Review of weight limits in Highgate

Proposed joint submission of Highgate Society and Neighbourhood Forum

Cordon proposed by Haringey

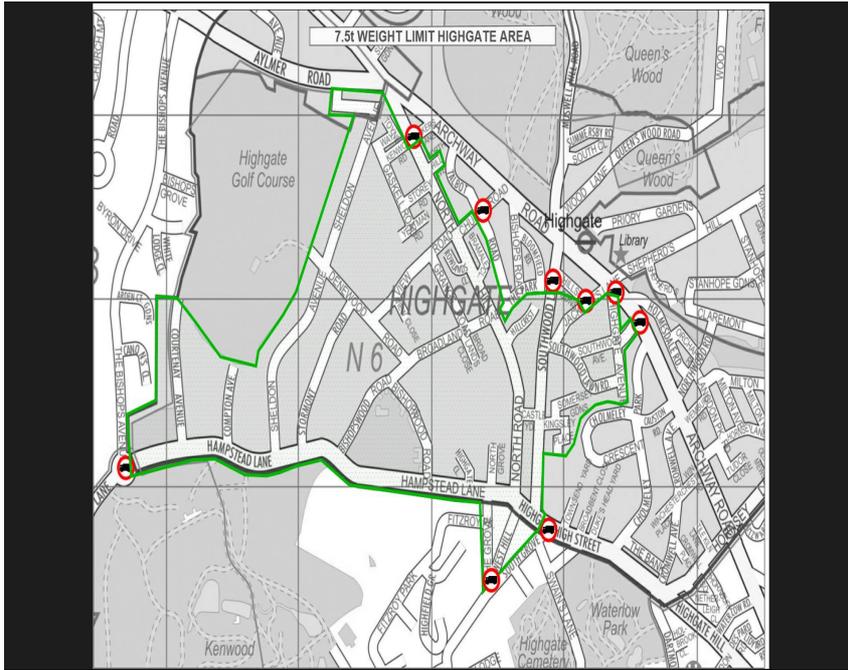
Our understanding is that though these restrictions affect individual streets, the streets affected are defined by the outer cordon, the line of which is shown on the map following supplied by Bethlehem Girma on 29 July.

If the purpose of these restrictions is to protect Highgate Village from through traffic it should apply to South Grove which, it could be argued, is the section of the Village which needs protection most. In the map supplied by Haringey South Grove does not appear to lie within the cordon. At its junction with West Hill there is no restriction. However the advance warning sign outside Channing School indicates a weight limit of 7.5 tonnes. It is all very confusing.

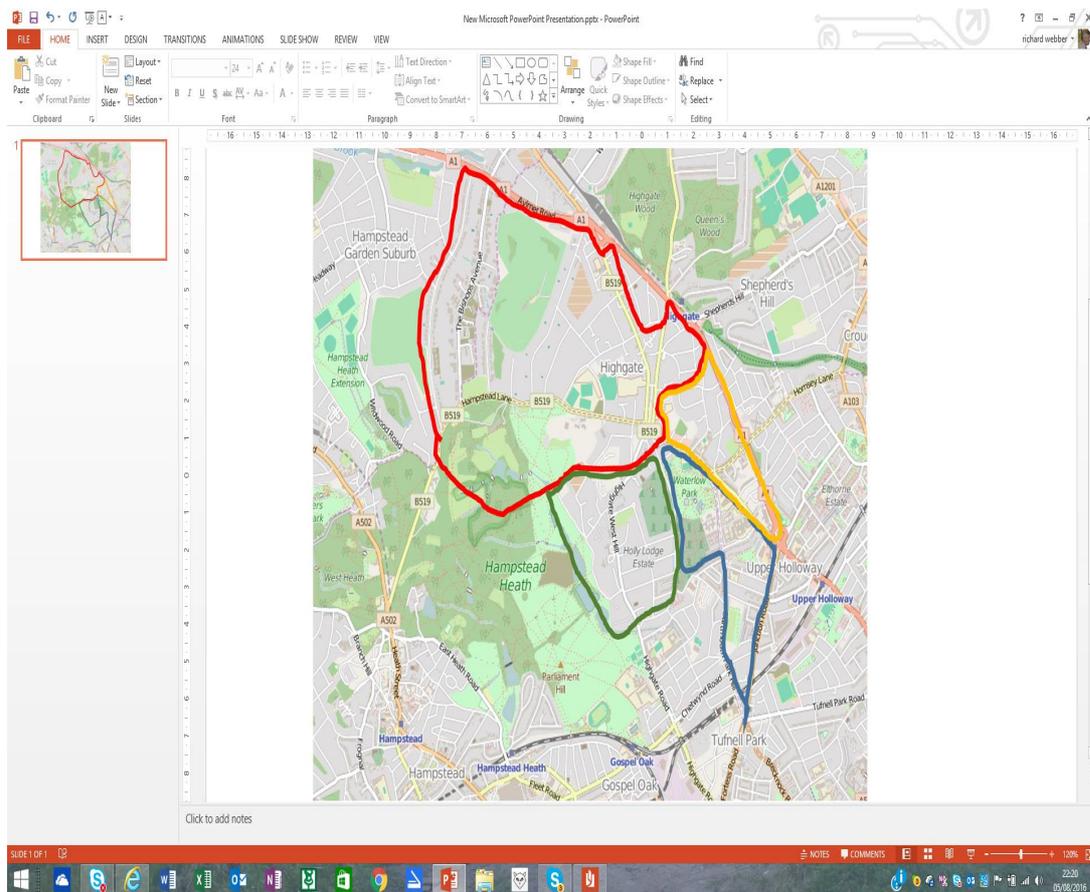
A map showing both the current Highgate cordon and the North Islington one suggests that it would be logical to join the two together to make a single expanded one with a more rational boundary as shown in the map below.

The red cordon is that which Haringey believes the current restricted zone applies to together with neighbouring parts of Barnet which share the same restriction.

The blue cordon is that part of Islington with an existing weight control together with Bisham Gardens.

South Grove is the only route between the two cordons. It is currently restricted in one direction but not in the other, and so status unclear.

The orange cordon contains parts of Haringey and Islington that we believe should be added to the existing restricted areas so as to create a single cordon. The particular merit of this extension is that overweight vehicles do not have to do a U-turn when they reach Highgate Village or use residential streets as an alternative, depending on where the warning signs are located.

Likewise the green cordon contains parts of Camden, much of it Holly Lodge and Swains Lane which ought not to be left uncontrolled and which, if controlled, would then prevent overweight vehicles having to turn round outside the Flask.

We are also recommending that Talbot Road, The Park and adjoining roads all need to be within the cordon.
